HISTORIC PRESERVATION COMMISSION

MEMORANDUM

SUBJECT: Historic Area Work Permit #1050805 – REVISION - Construction of new single-family home,

grading, hardscape and other alterations

SITE PLAN

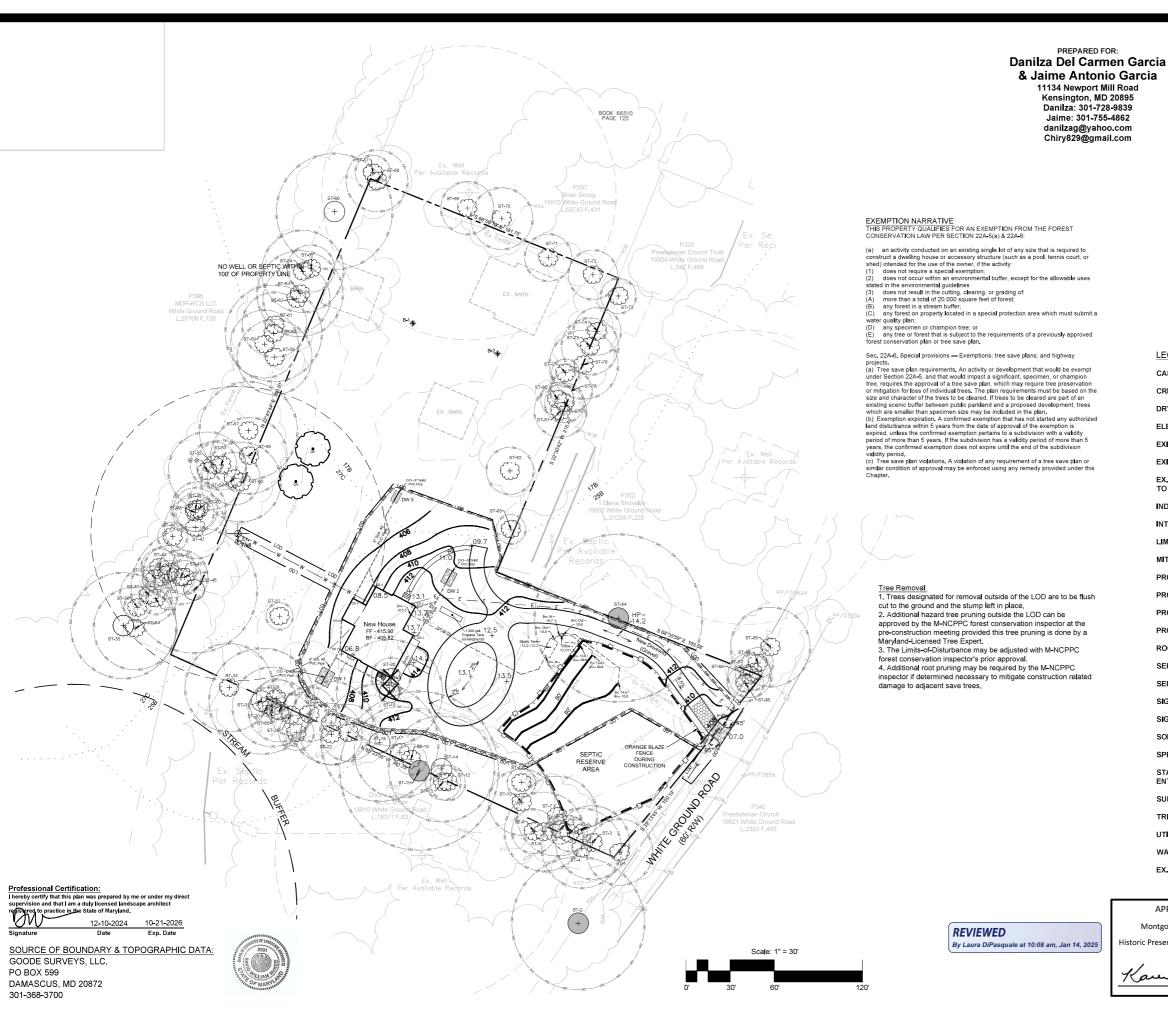
Approved New Construction Site Plan on HAWP # 1050805 has a distance of 208 ft. from the road, new site plan has a distance of 176 ft. from the road to comply with zoning review that any accessory structure must be located behind the rear building line of the principal building.

Work Item 1: HAWP Revision						
Description of Current Condition: Approved site plan on HAWP # 1050805 has a construction distance of 208 ft. from the road.	Proposed Work: To change the distance from 208 ft to 176 ft. from the road.					
REVIEWED	APPROVED Montgomery County					
By Laura DiPasquale at 10:33 am, Apr 29, 202 Work Item 2:	Historic Preservation Commission					
Description of Current Condition:	Proposed Karen Bulit					
Work Item 3:						
Description of Current Condition:	Proposed Work:
